Operational Alert: 160
Date: January 3, 2006
Subject: Fuel Cap Vent Hole
Compliance: Mandatory
Models Affected: S-7S, S-9, S-10

FIGURE OA-160

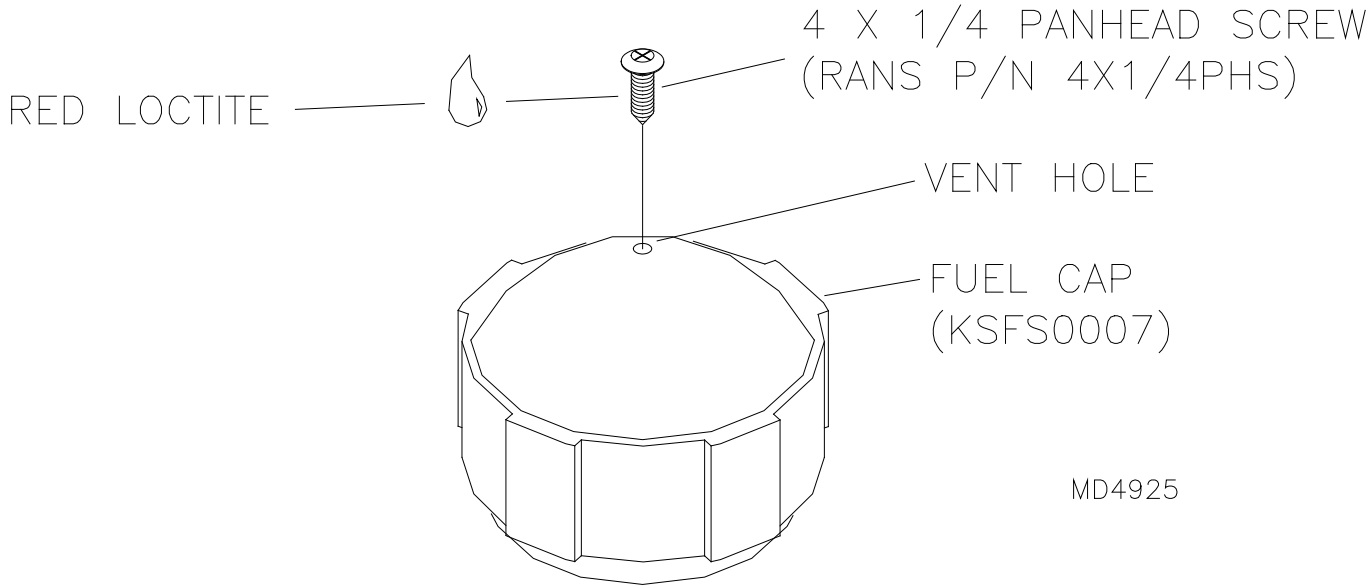
Fuel Caps (KSFS0007) were received from the supplier with a Vent Hole drilled into the top center. The Vent Hole may allow fuel to be drawn out the top of the cap. Plugging of the Vent Hole is required as shown in **FIGURE OA-160**. Parts are available from RANS or from a local hardware store.
